TRAFFIC LOOP LAYOUT SHEET #4

PROJECT NAME: WALLINGFORD - RUTLAND TOWN
 PROJECT NUMBER: AC NH 2207(1)S

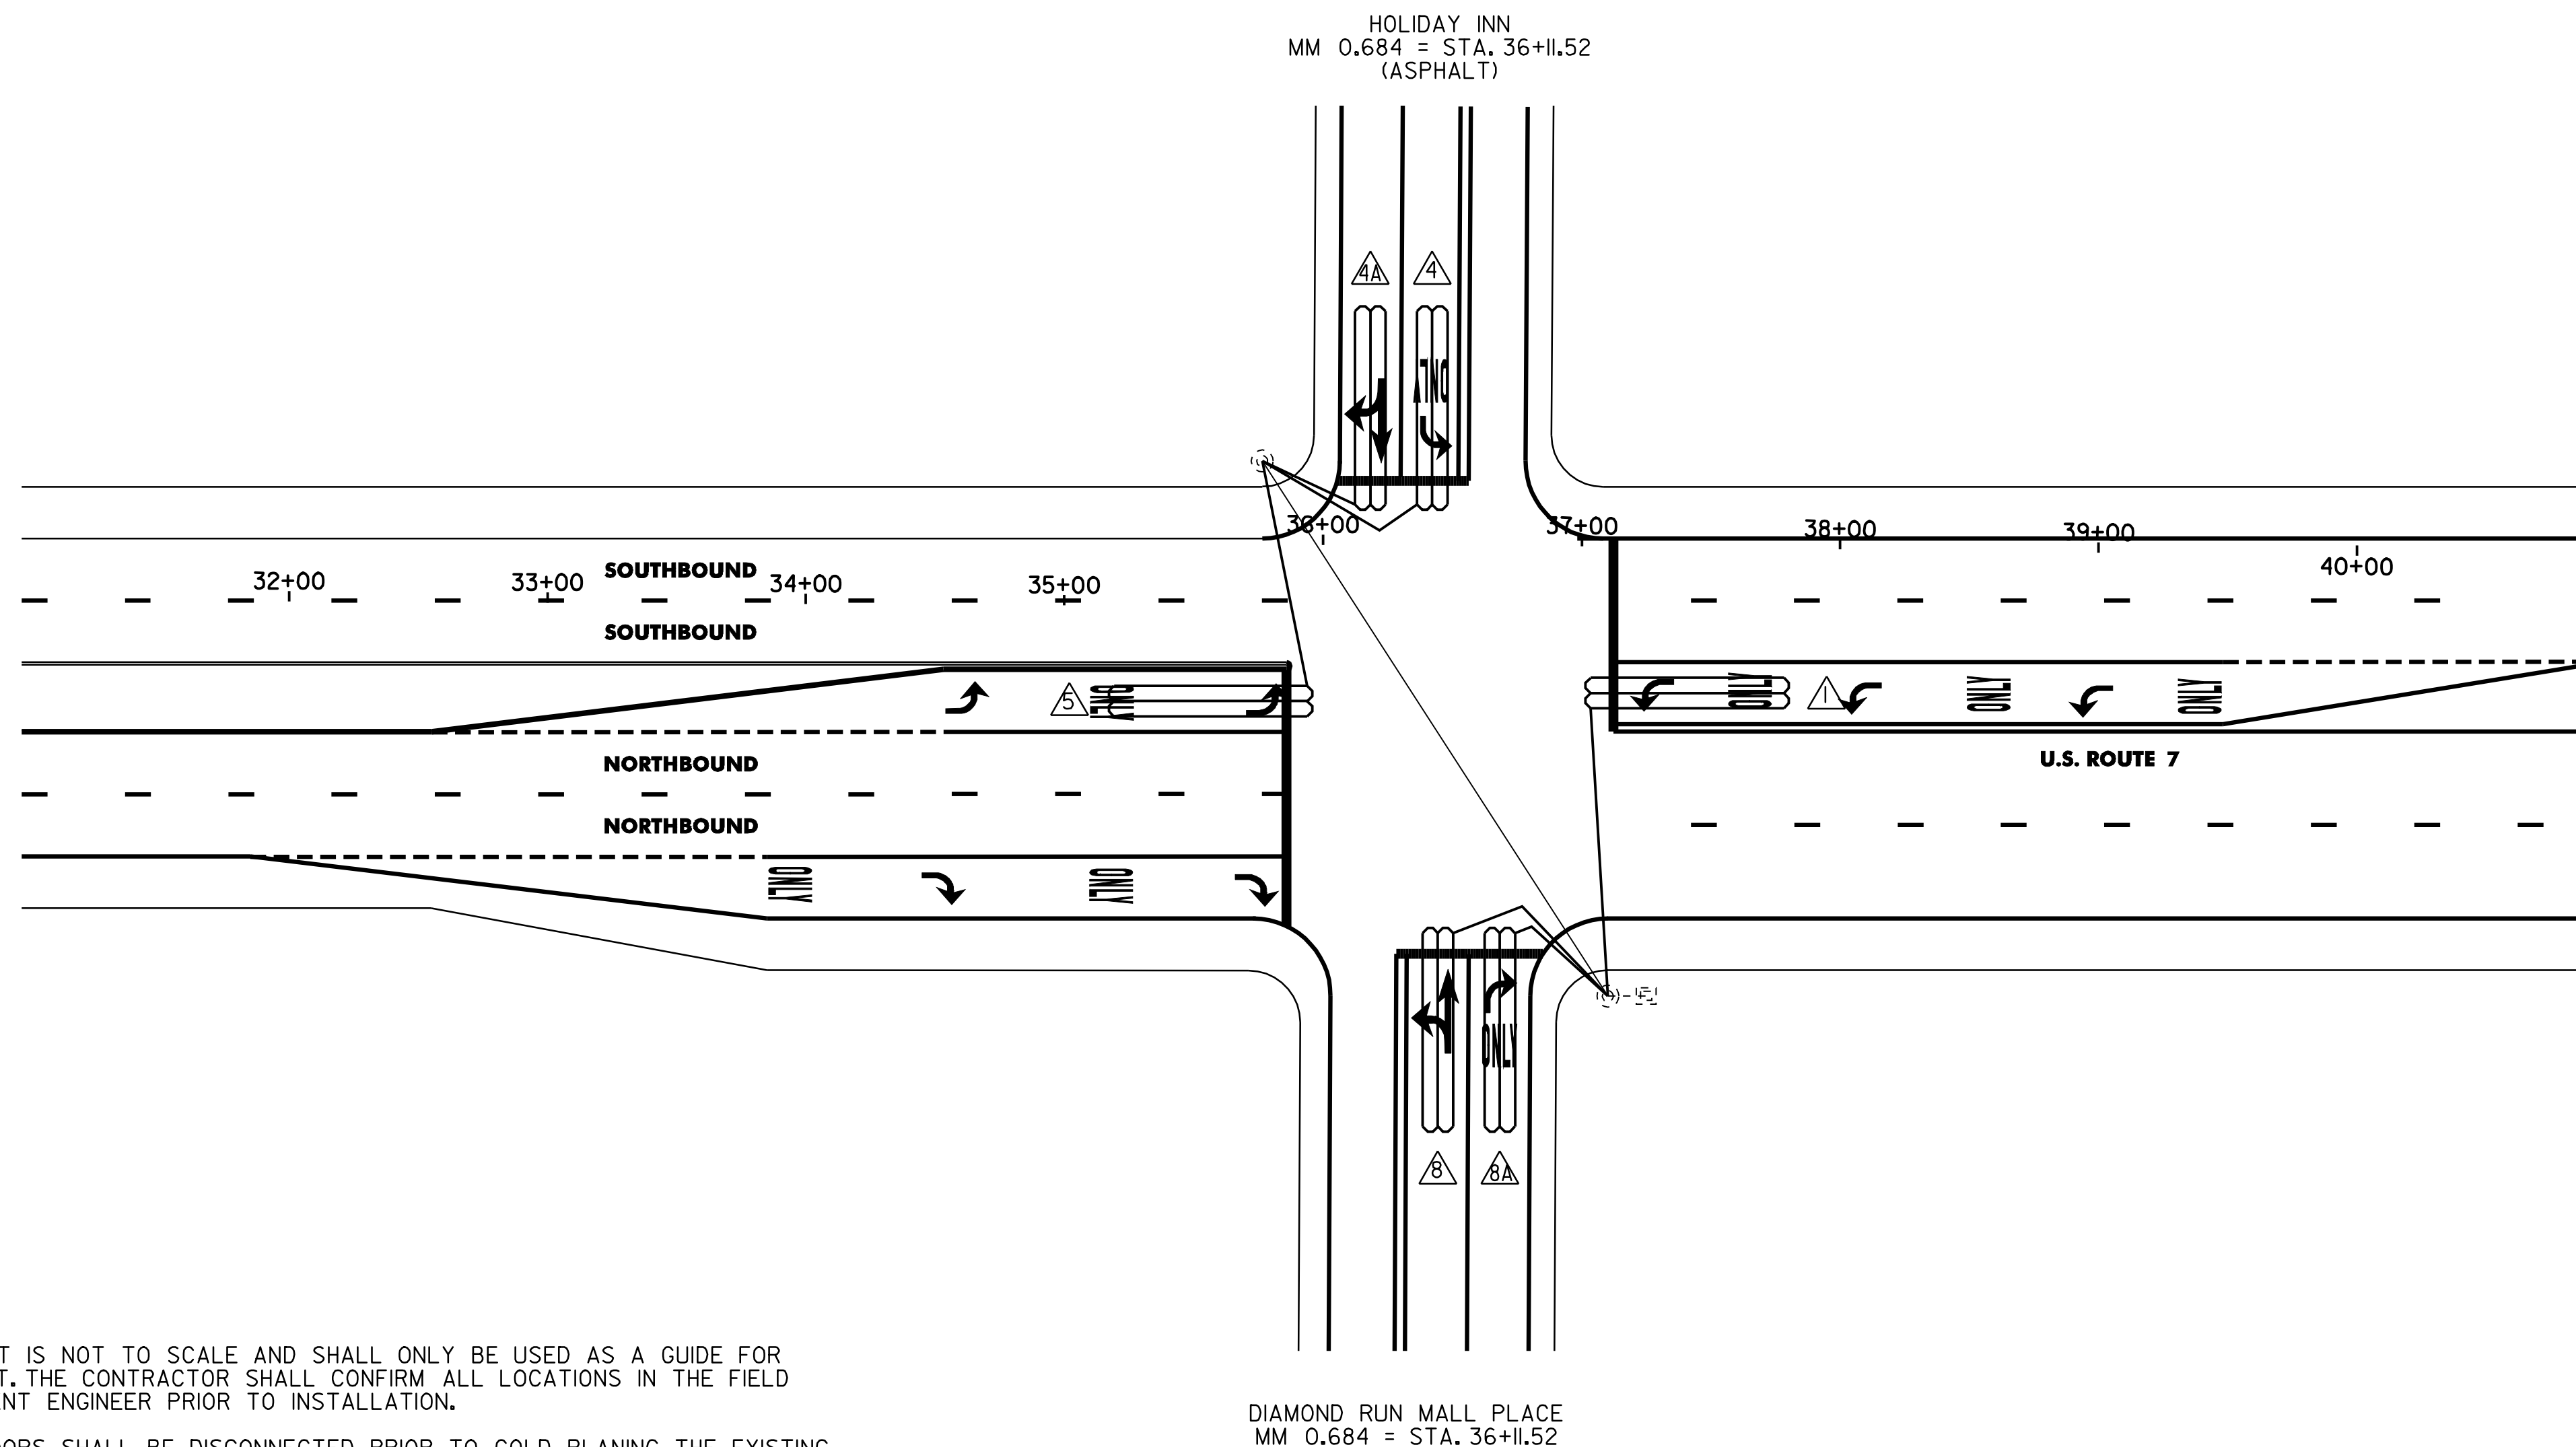
LOOP 1	-	182 FT	185 FT
LOOP 4	-	160 FT	159 FT
LOOP 4A	-	147 FT	142 FT
LOOP 5	-	171 FT	179 FT
LOOP 8	-	160 FT	158.5 FT
LOOP 8A	-	147 FT	145 FT
